**Planning & Environment**
Issued under the Environmental Planning and Assessment Act 1979
Approved Section 4.55 (.....) Modification Application
No. 3 granted on the 8 May 2019
in respect to SSD 7484
Signed AD
Sheet No. 1 of 33

PROJECT
**SANDSTONE
PRECINCT**
23-39 BRIDGE STREET, SYDNEY 2000, AUSTRALIA

PROPOSED SITE PLAN

DRAWING NUMBER
SP-DA-G-1500

**LANDS BUILDING - LEVEL 03,
EDUCATION BUILDING -
LEVEL 02**

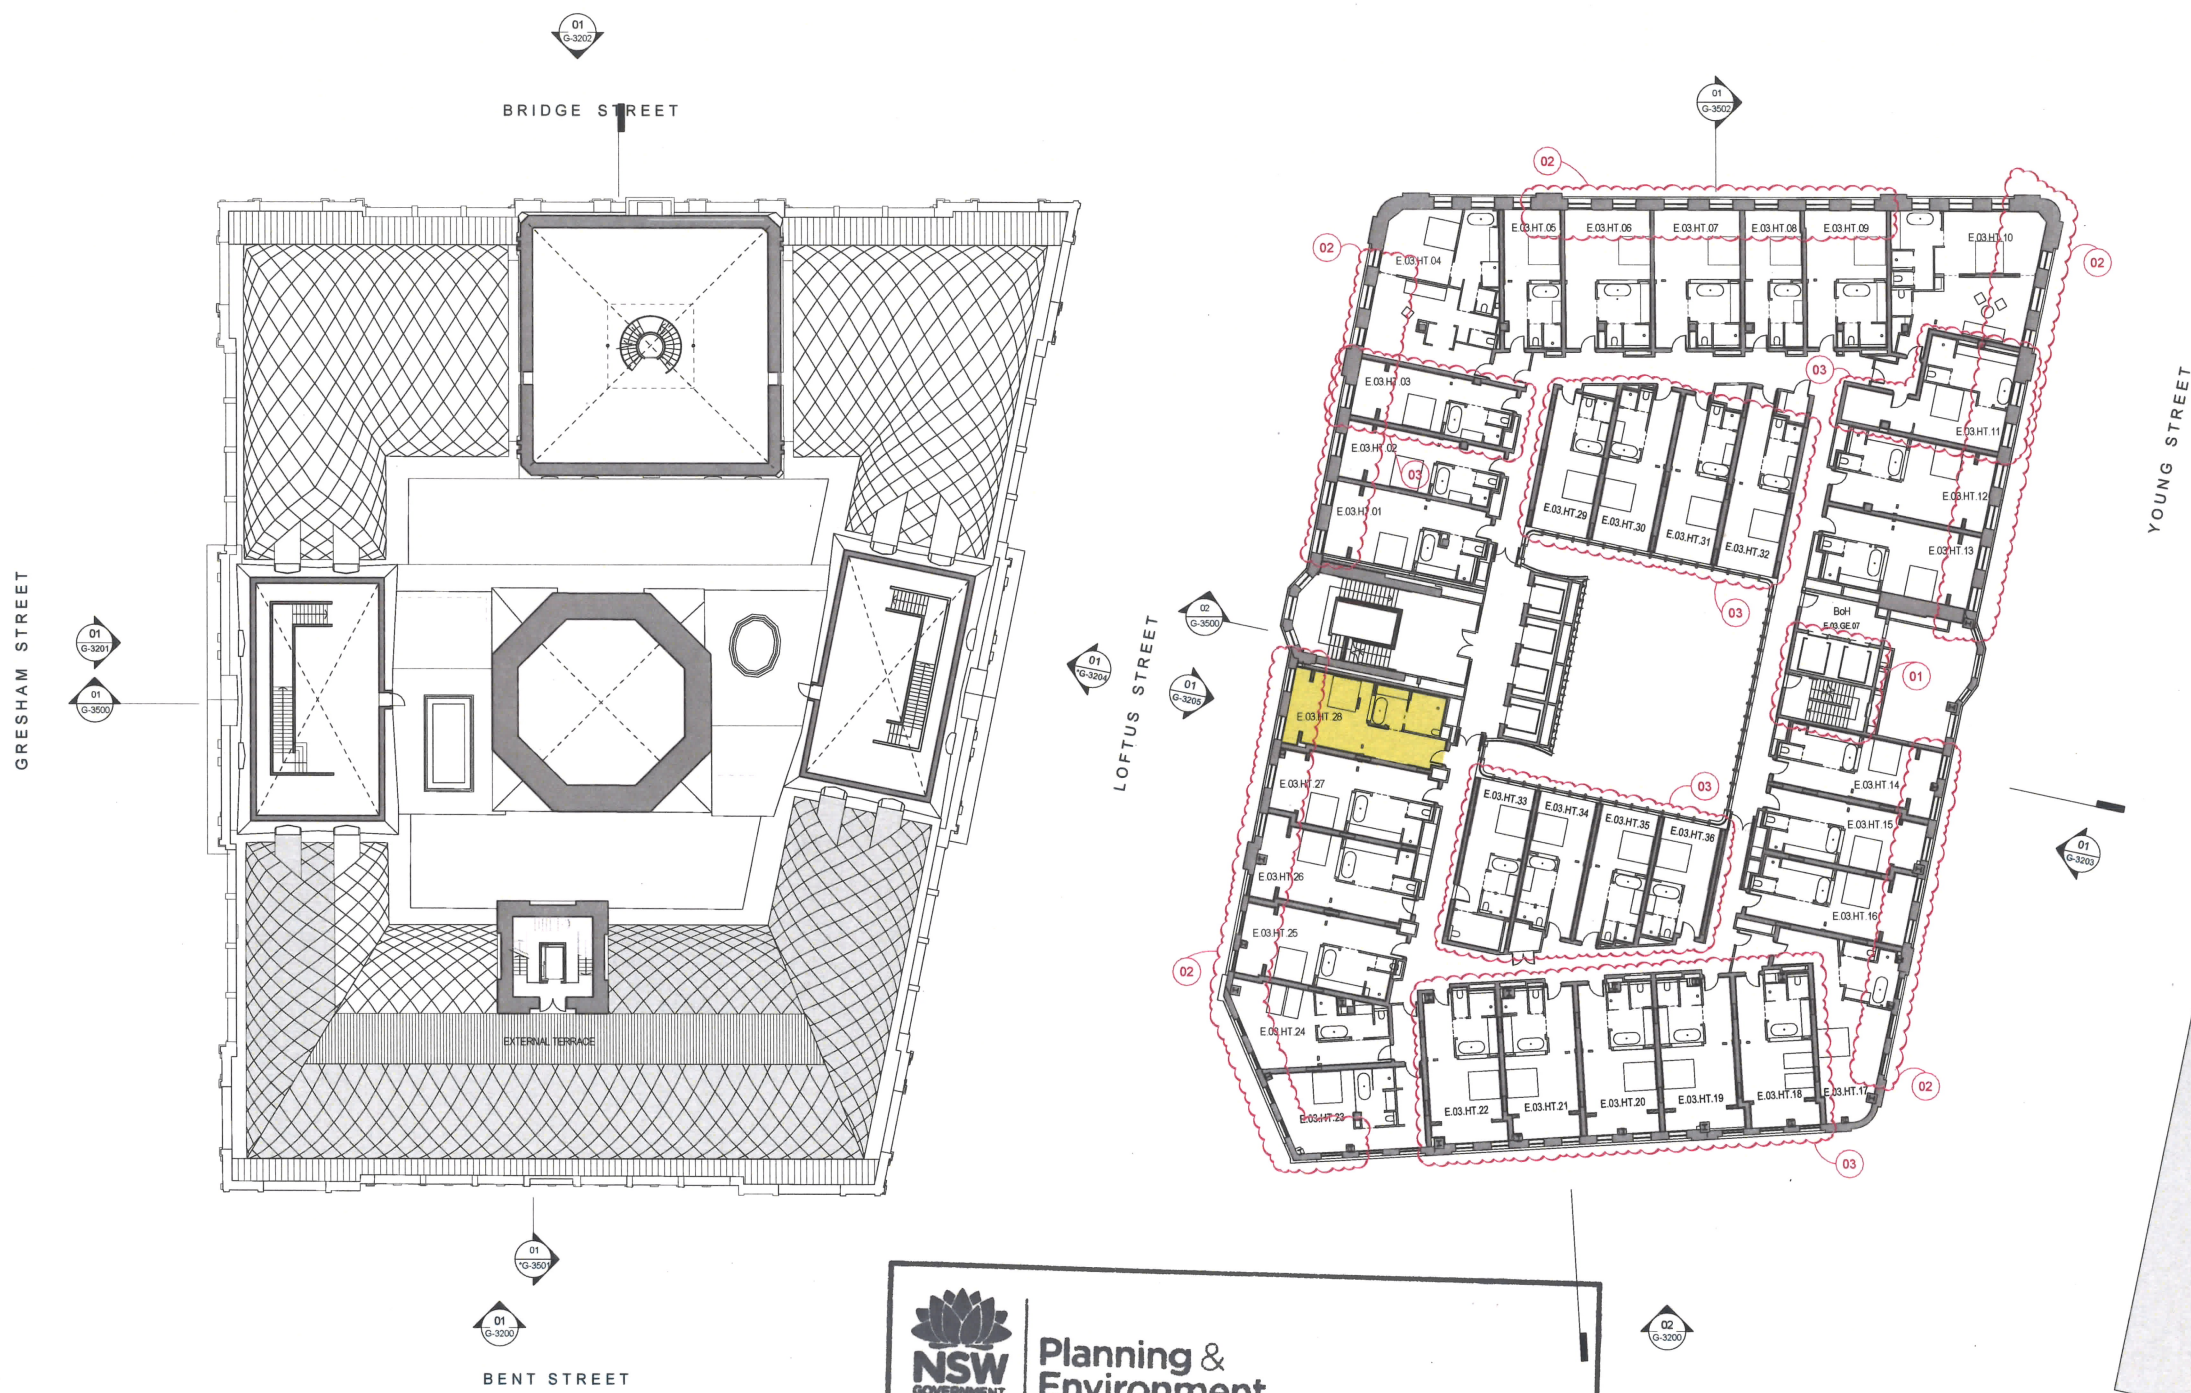
CHANGES LEGEND:
01 COURTYARD GLAZED ROOF MOVED
DOWN TO LEVEL 2 FROM LEVEL 6
02 BOH LIFTS AND STAIR MOVED NORTH TO
CREATE A MORE EFFICIENT CORE
03 WINTER GARDENS REMOVED AND
SECONDARY GLAZING INSTALLED
04 ADDITIONAL KEY

PROJECT NUMBER **1166**
SCALE **1:200@B1** DRAWN **BV** CHECKED **CZ**
STATUS
FOR APPROVAL
DRAWING
PROPOSED PLANS
**LANDS BUILDING - LEVEL 04,
EDUCATION BUILDING -
LEVEL 03**
DRAWING NUMBER **SP-DA-G-2503** ISSUE **04**

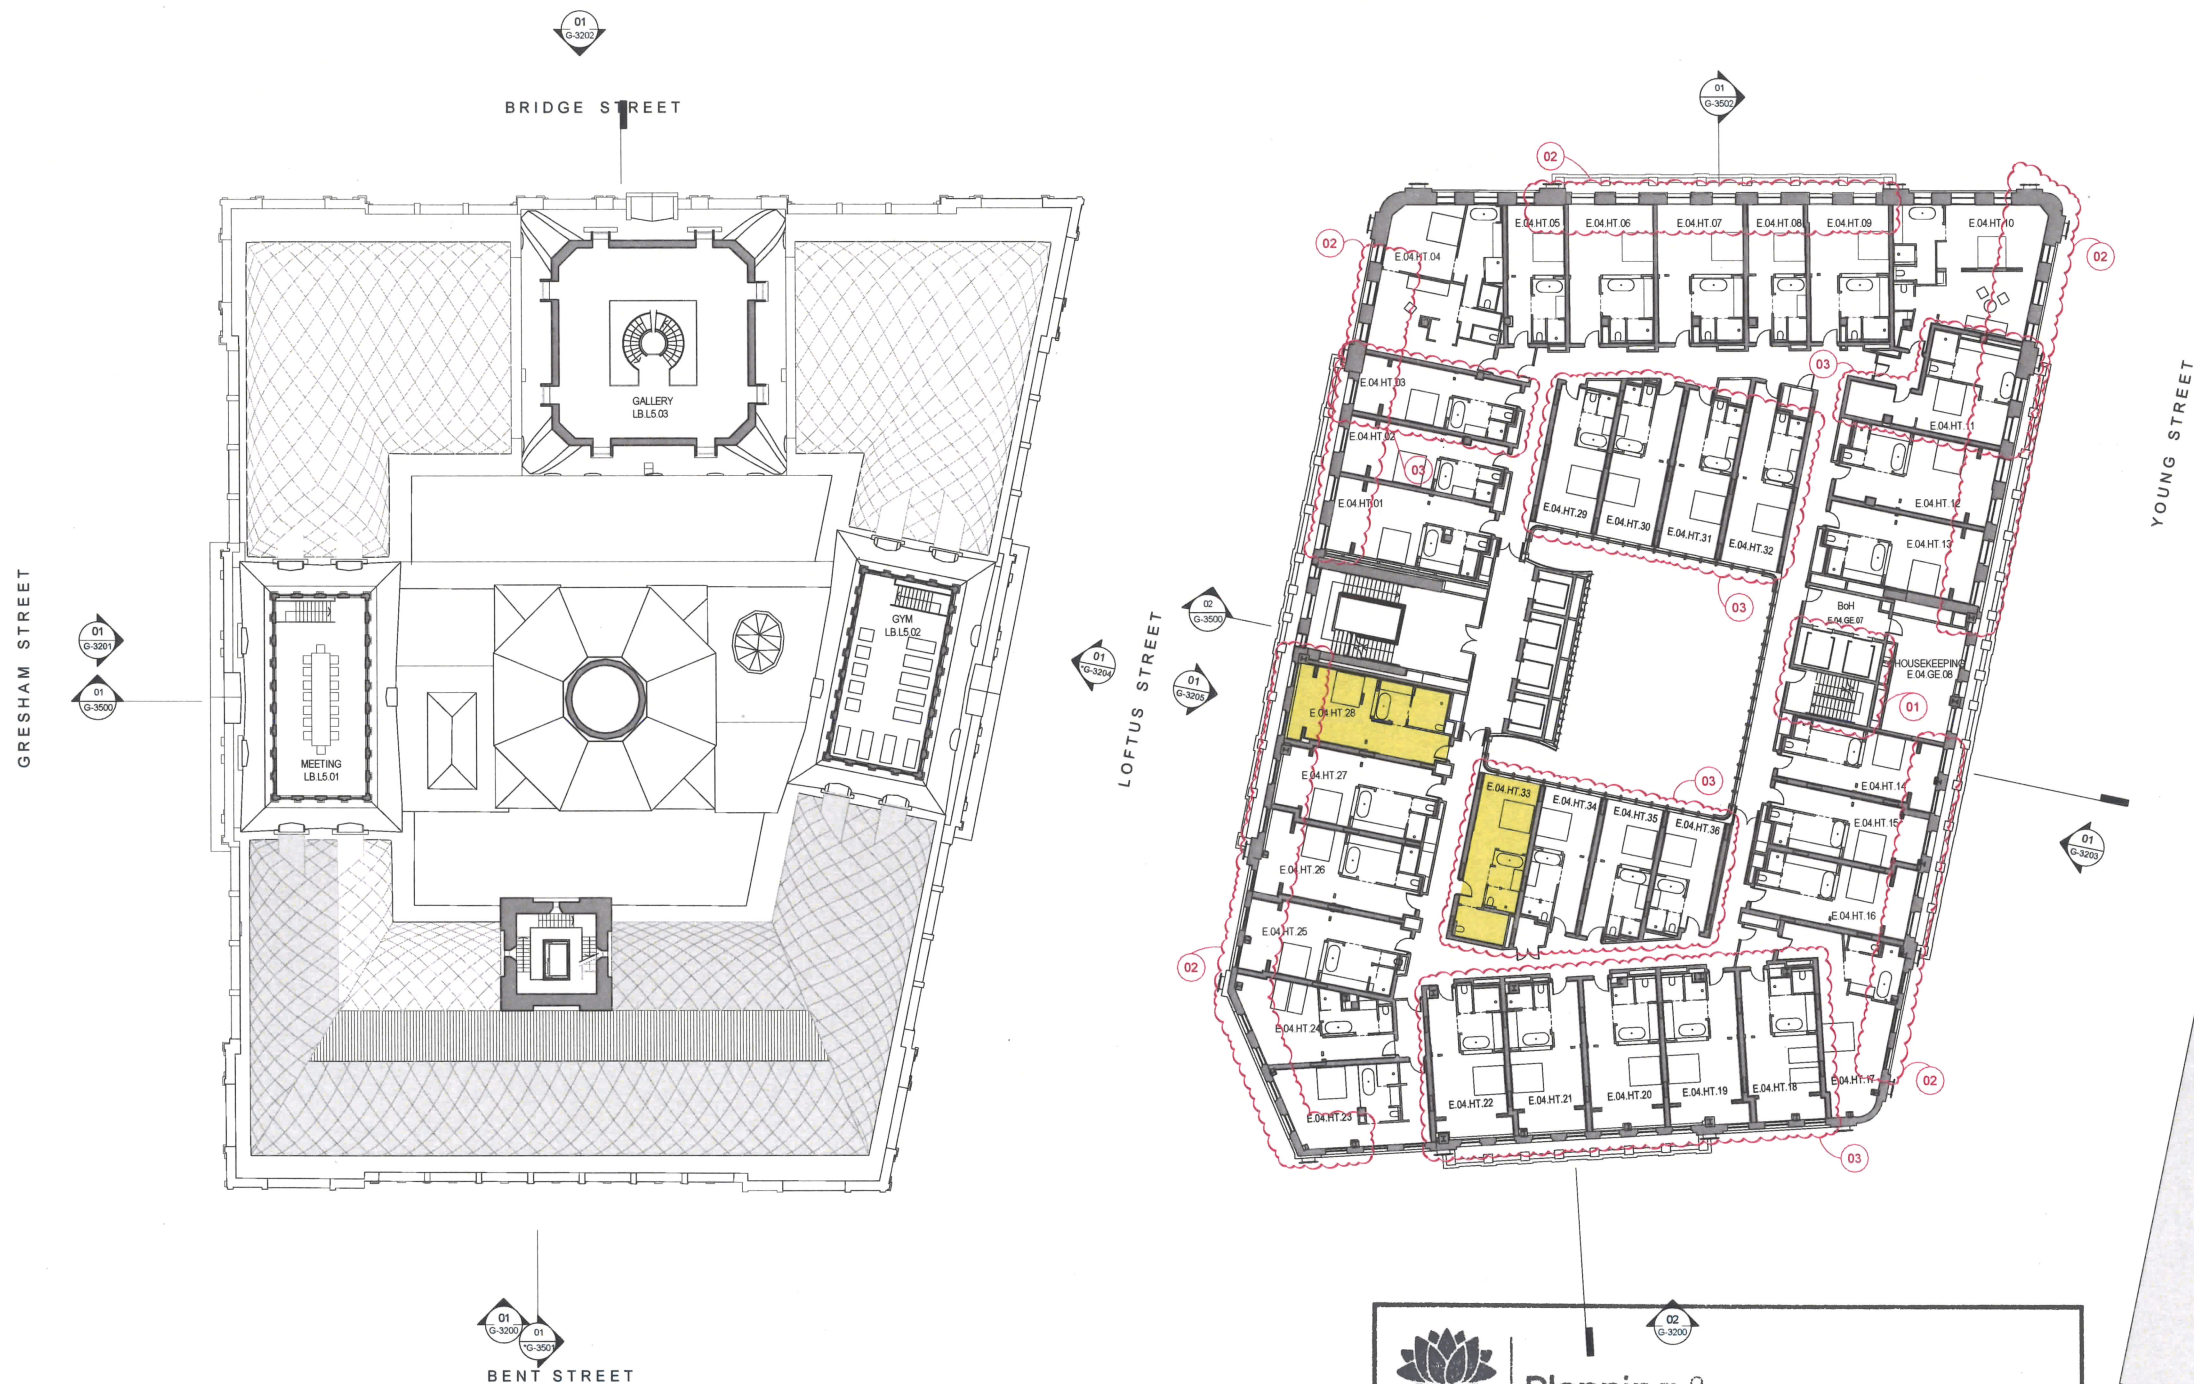
CHANGES LEGEND:
01 BOH LIFTS AND STAIR MOVED NORTH TO
CREATE A MORE EFFICIENT CORE
02 WINTER GARDENS REMOVED AND
SECONDARY GLAZING INSTALLED
03 ADDITIONAL KEY PER ZONE

**LANDS BUILDING - LEVEL 05,
EDUCATION BUILDING -
LEVEL 04**

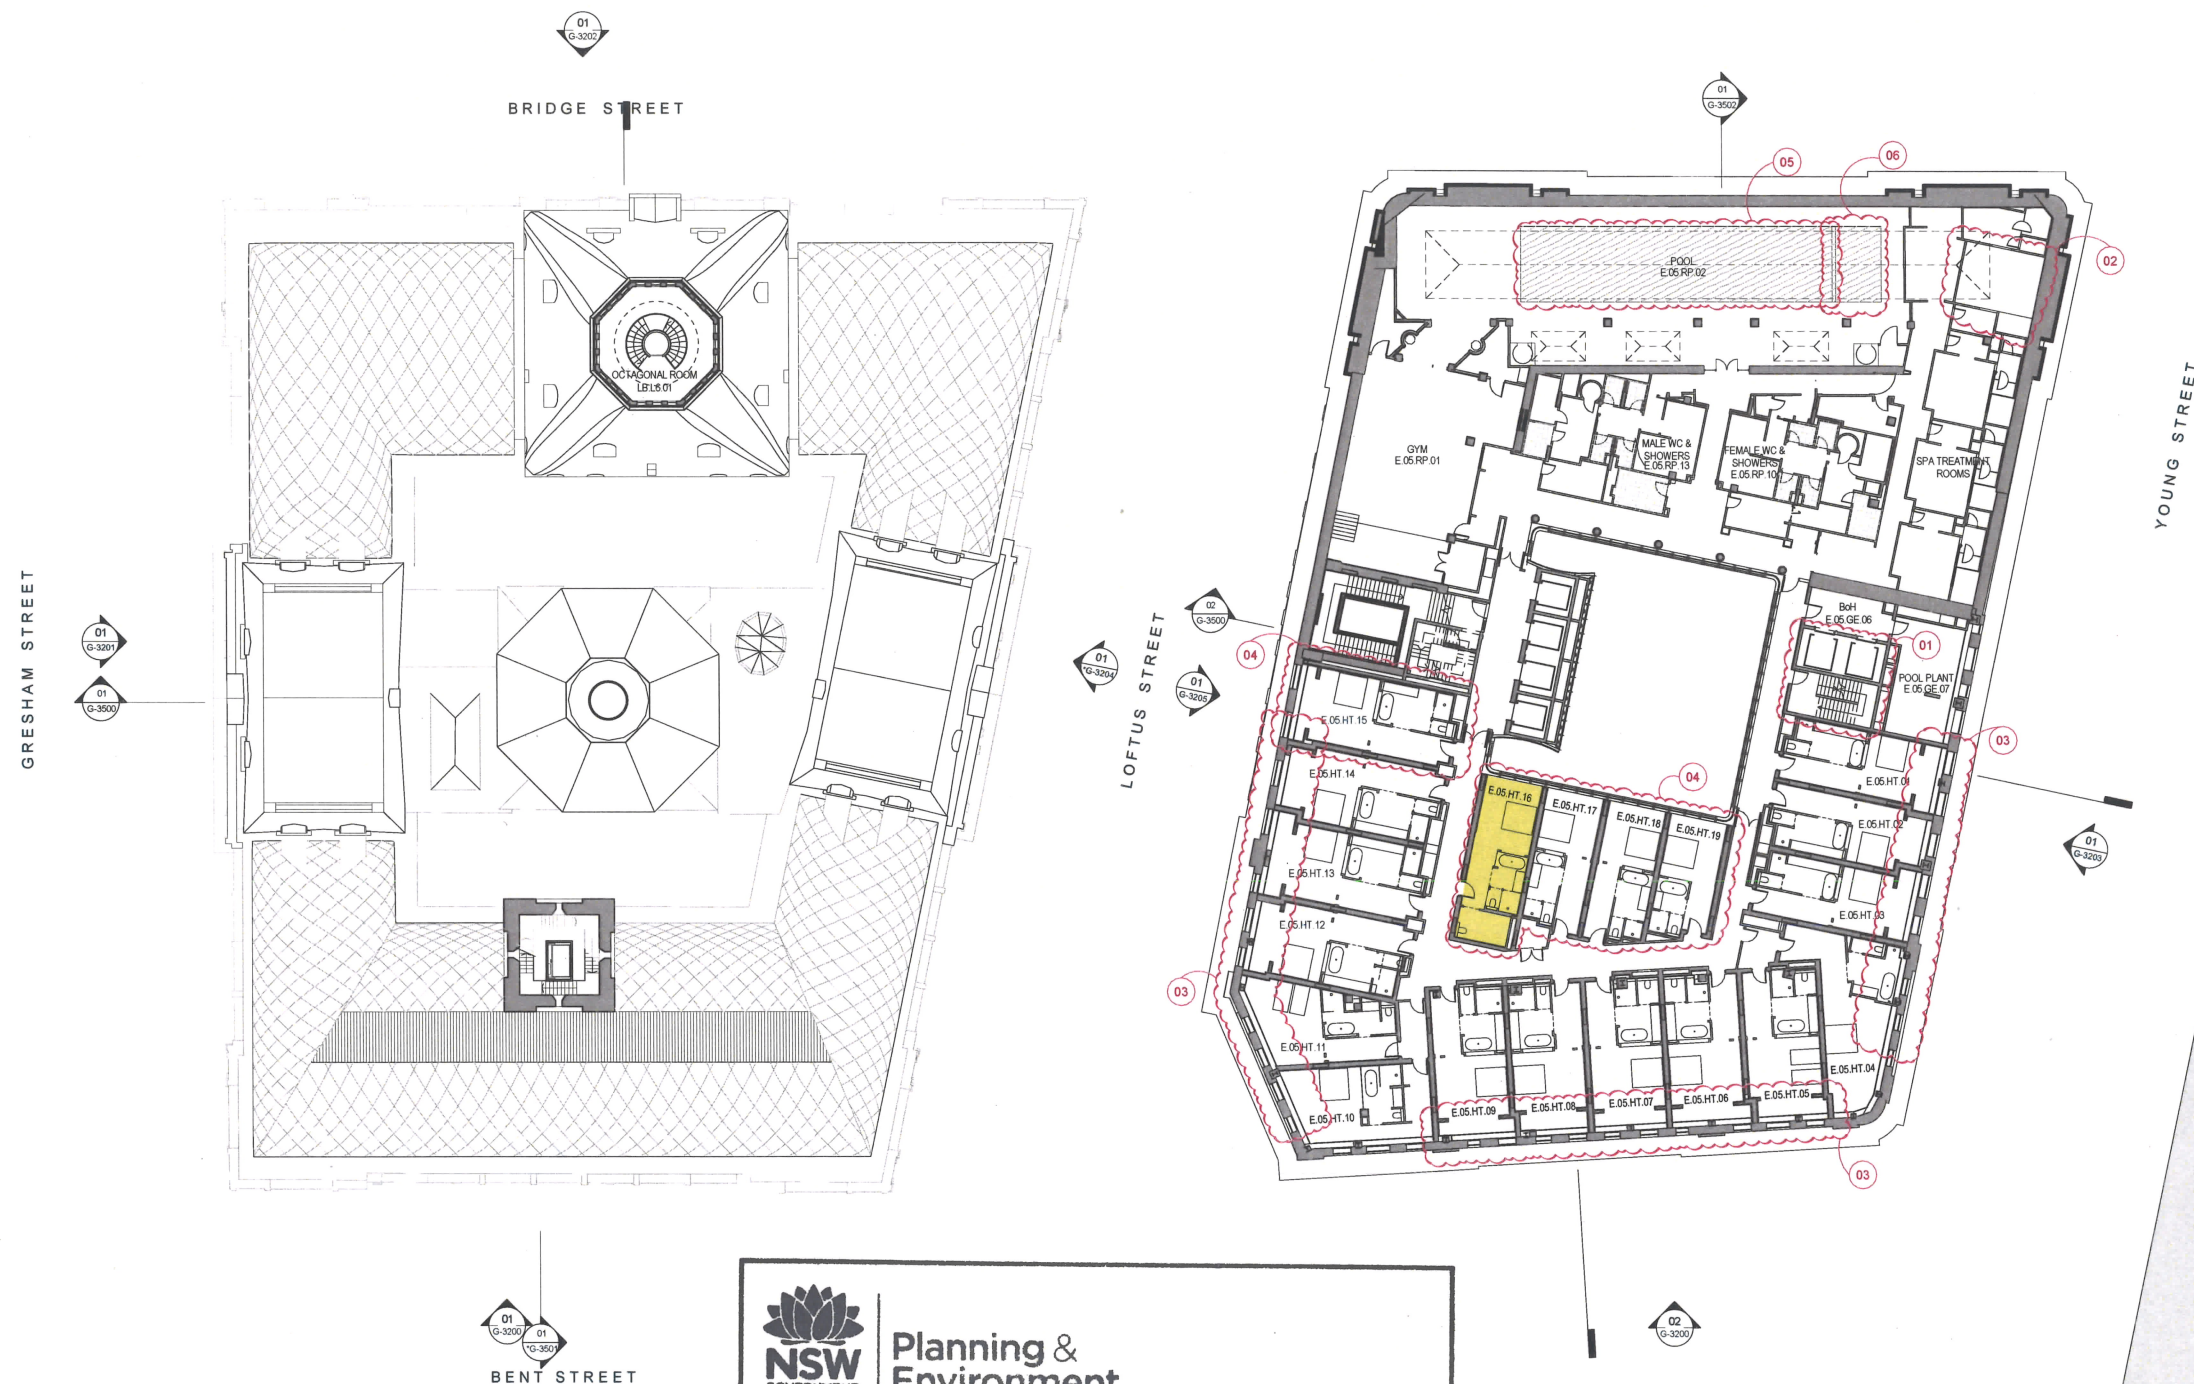
- 01 BOH LIFTS AND STAIR MOVED NORTH TO CREATE A MORE EFFICIENT CORE
- 02 WINTER GARDENS REMOVED AND SECONDARY GLAZING INSTALLED
- 03 ADDITIONAL KEY PER ZONE
